**TOWN OF FORT MILL  
PLANNING COMMISSION MEETING  
March 24, 2015  
112 Confederate Street  
7:00 PM**

**Final Plat Approval: Springview Meadows Phase 2**

**Sketch Plan: Kimbrell Road Property**

## 35' Buffer Area

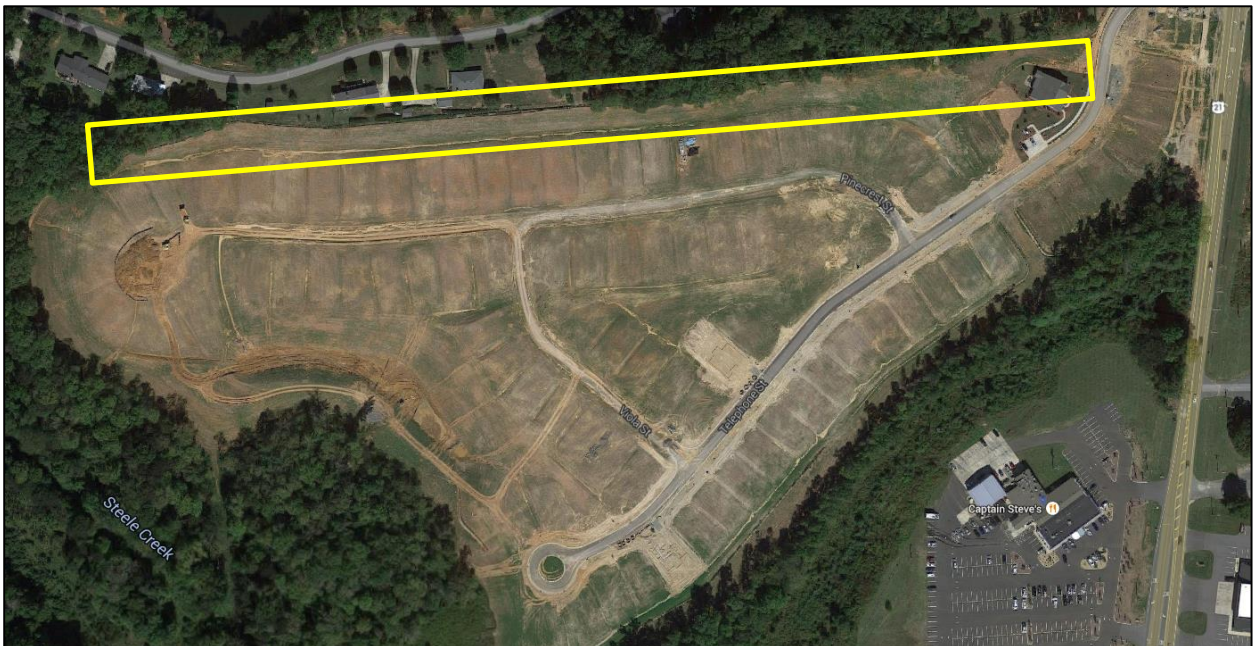
In addition, the 35' natural buffer along the northern edge of the property was disturbed during clearing and grading activities. This buffer is required by the R-5 district ordinance, and was shown on the preliminary plat. The R-5 buffer requirement is included below, for reference:

In addition, staff recommends that approval of the final plat for Phase 2 shall also be contingent upon the applicant replanting (or bonding the replanting) of the required 35' buffer along the northern boundary of the property, as required by the R-5 district.

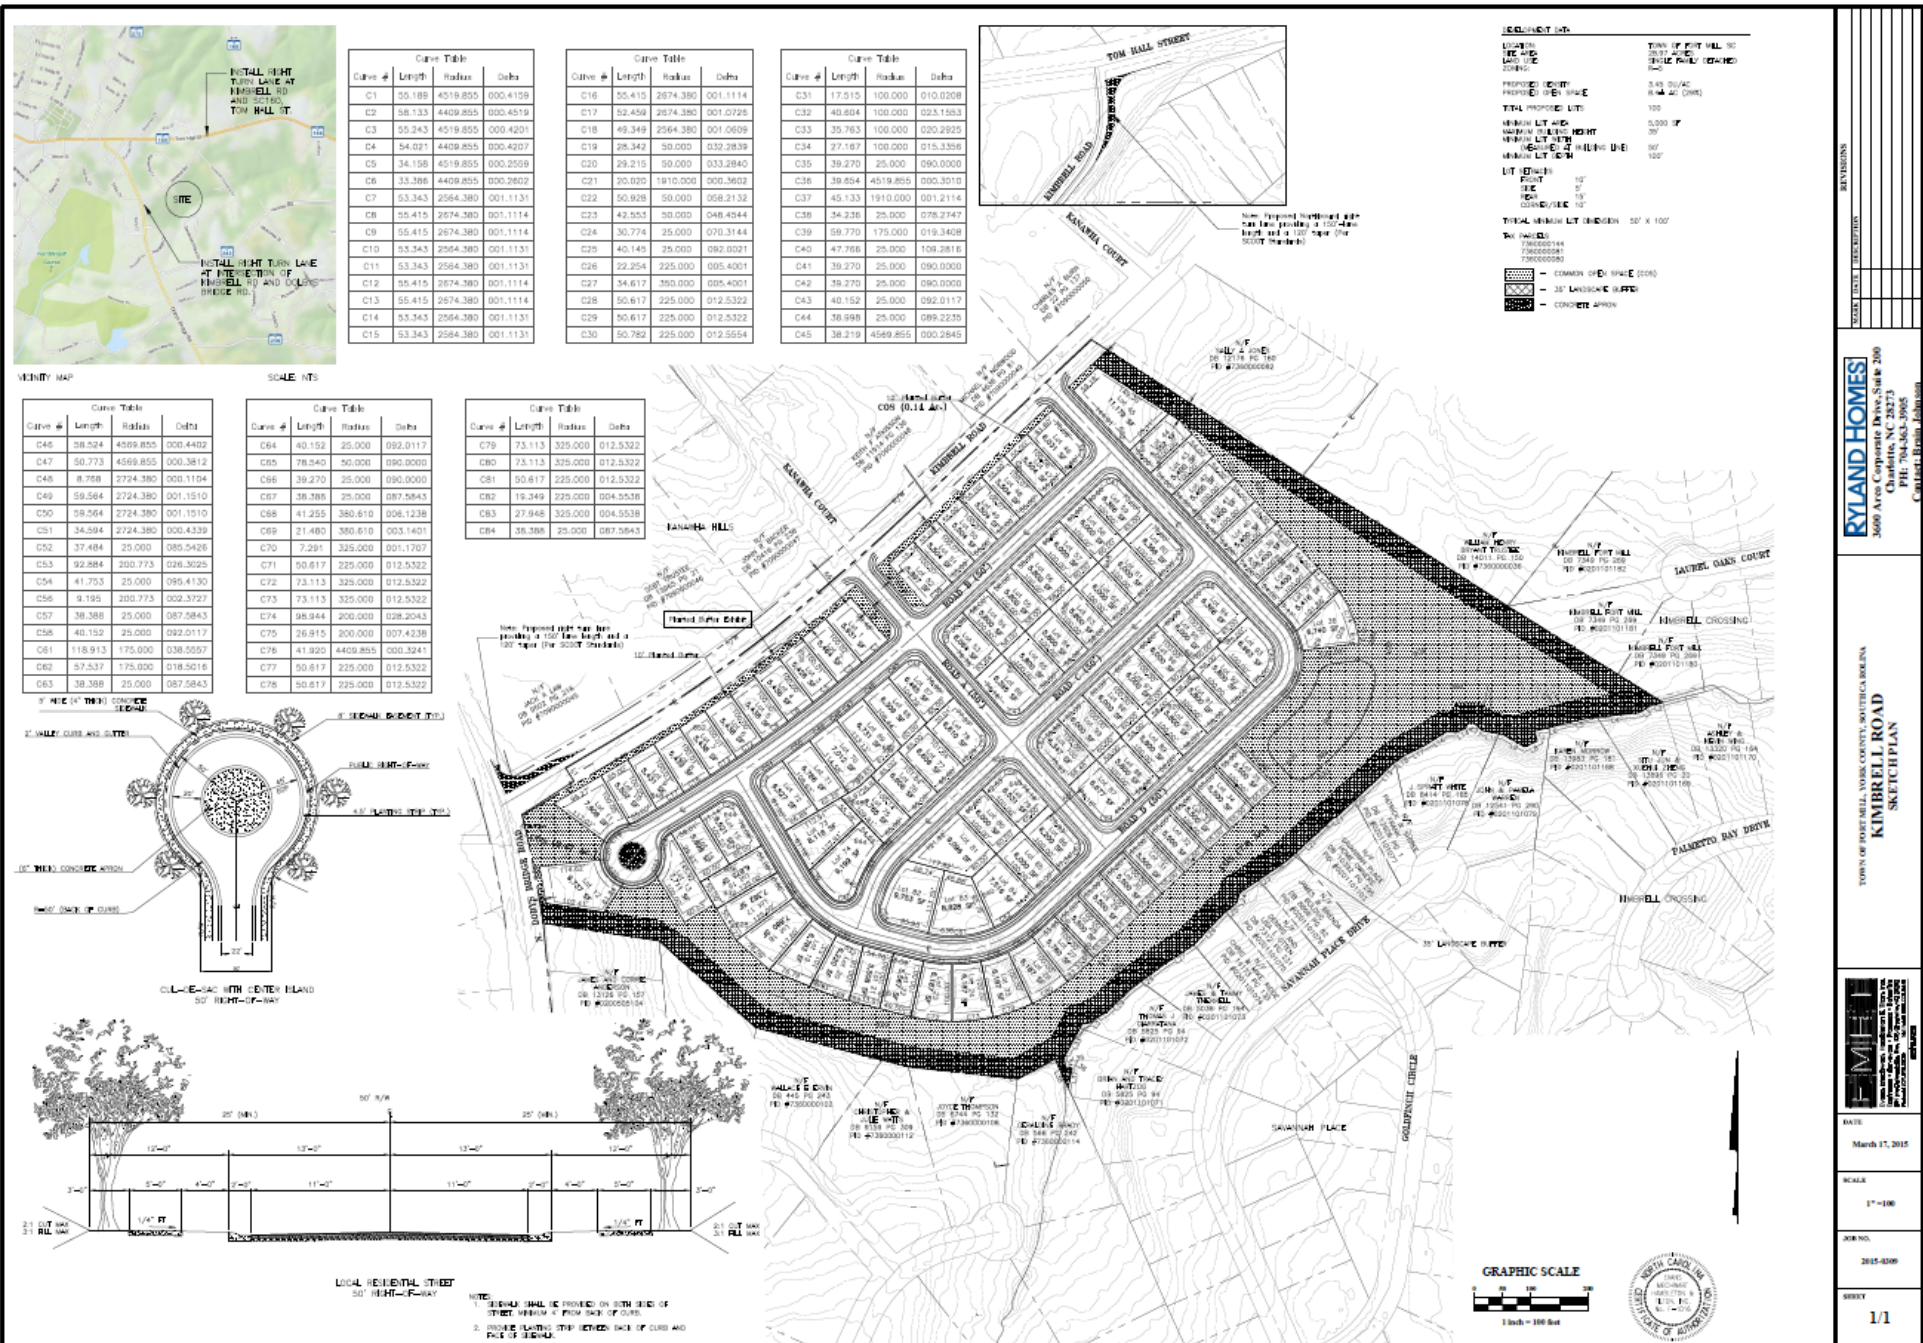
- Road stub outs. The site plan does not include any street stub outs or preservation of rights-of-way to allow future connectivity to neighboring parcels, particularly those on the northeast boundary of the property. Should those neighboring lots develop (or redevelop)

at a later date, no internal connectivity to this subdivision would be possible based on the current layout.

- Off-site improvements. The sketch plan references two off-site improvements, which were required per Paragraph IX(D) of the development agreement. These improvements include the addition of a right-turn lane at both ends of Kimbrell Road (one at N Dobys Bridge Road, and another at Tom Hall Street). These off-site improvements will be coordinated with, and approved by, SCDOT.
- Sidewalks. While internal sidewalks are provided as required, the sketch plan does not show sidewalks on the N Dobys Bridge Road and Kimbrell Road frontages. Both the zoning ordinance and the development agreement require the installation of sidewalks (min. 5') along both frontages, to be stubbed out to neighboring property lines for future connectivity.

- Cul-de-sacs. The proposed layout includes one cul-de-sac. This cul-de-sac is shown with a concrete apron in the center. Most recently approved subdivisions, including Springfield, River Chase, Sutton Mill and Springview Meadows, have installed landscaped medians within cul-de-sacs. These landscaped medians reduce the impervious area within each cul-de-sac, and provide an added level of beautification.
- Landscaped corridor. The applicant has proposed a buffer plan, a copy of which is attached. Below is a summary of the buffer requirements, as outlined in the development agreement:

Note: This buffer would need to be set behind an additional setback to accommodate the 5' min. wide sidewalks along the Kimbrell Road and N Dobys Bridge Road rights-of-way, unless the sidewalks were permitted to be located within the ROW by SCDOT.

Significantly sized live oaks flank the old Kimbrell Home on the property.

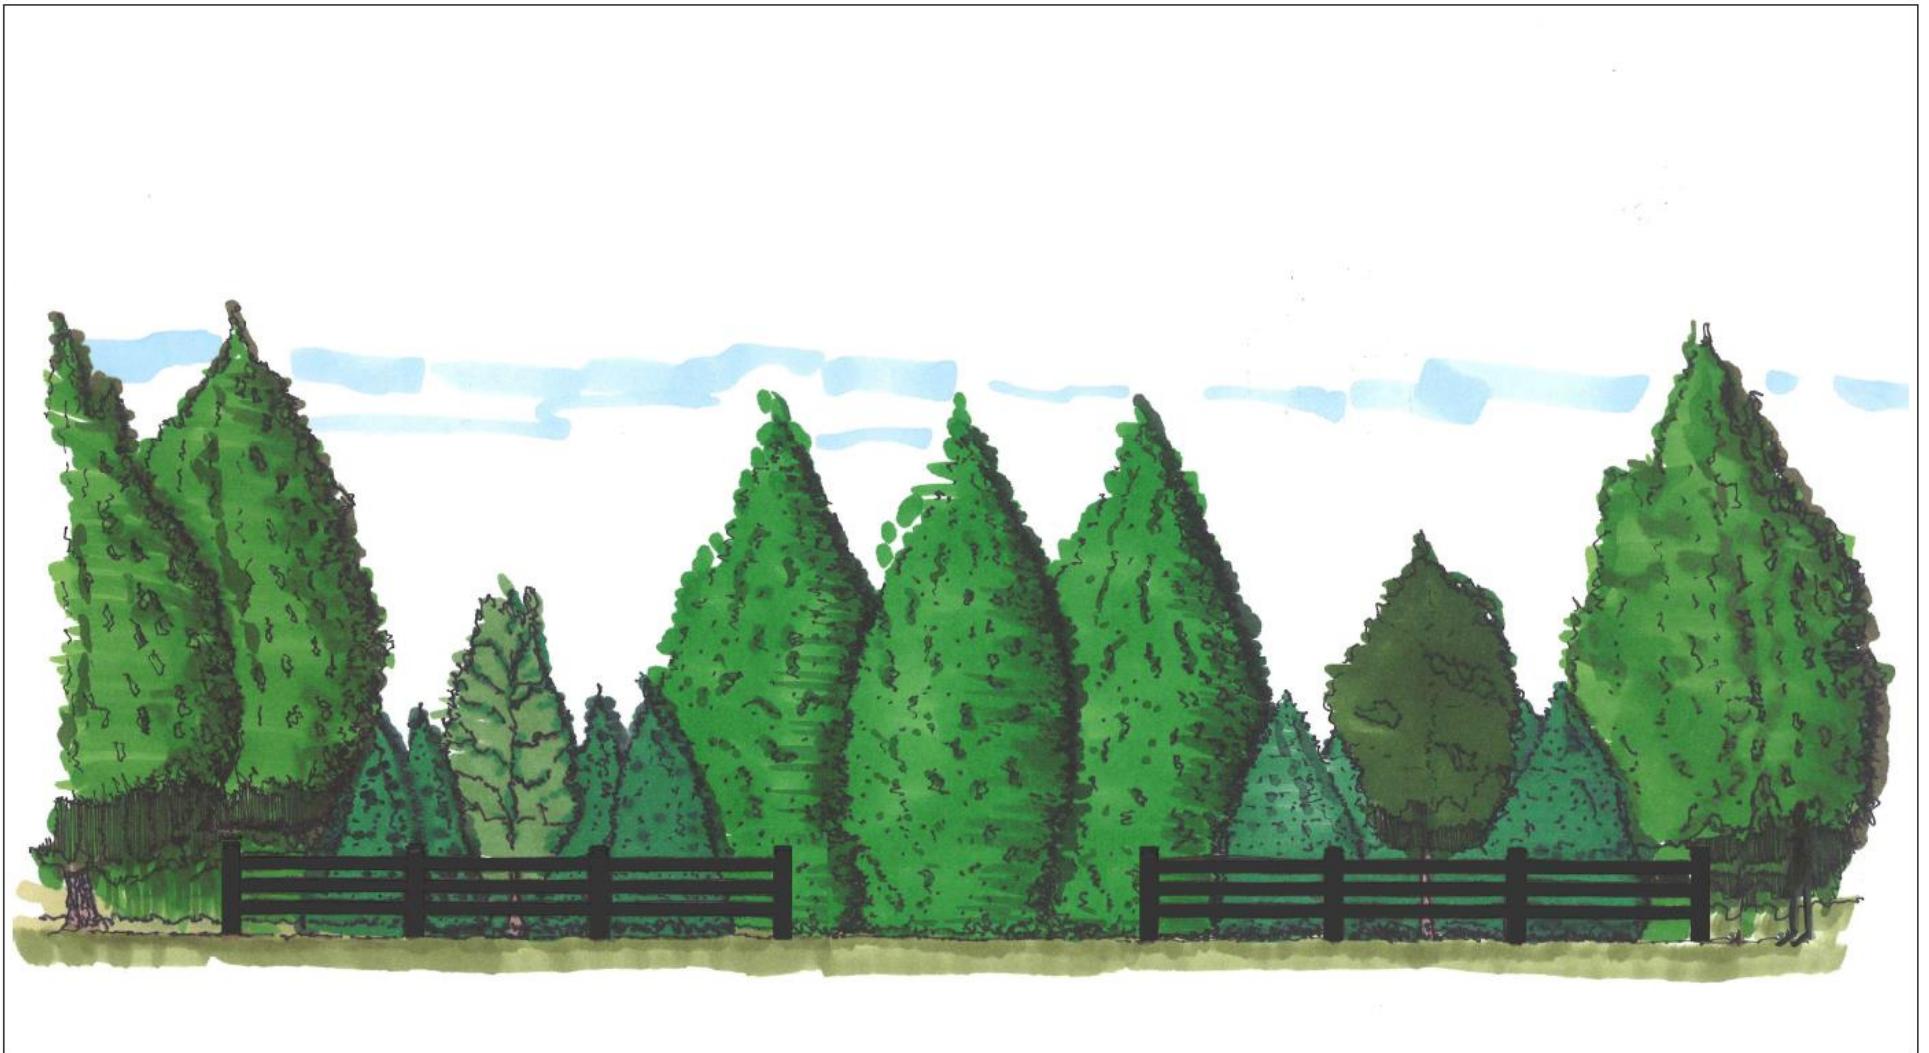
- Significant trees. The development agreement includes a preservation requirement for the grand tree located at the intersection of N Dobys Bridge Road and Kimbrell Road. The draft sketch plan does include a preservation area around this tree. Upon further review of the site, staff has identified at least two additional trees which would meet the “significant tree” preservation requirements of Article IV of the zoning ordinance. These two trees, both of which are very large live oaks, flank the two sides of the existing residence near the center of the property along the Kimbrell Road frontage. Based on the current layout, one tree appears to be within the path of the main access road, and the other appears on a residential lot. Should this project proceed as designed, both trees would need to be cut down and removed. While Article IV of the zoning ordinance does include provisions governing the removal of significant trees, the Planning Commission does have some authority regarding the proposed layout and location of streets. Given the size and age of these two trees, staff would recommend in favor of evaluating alternate layouts that would preserve, to the maximum extent possible, the integrity of these trees. (See attached for photos.)
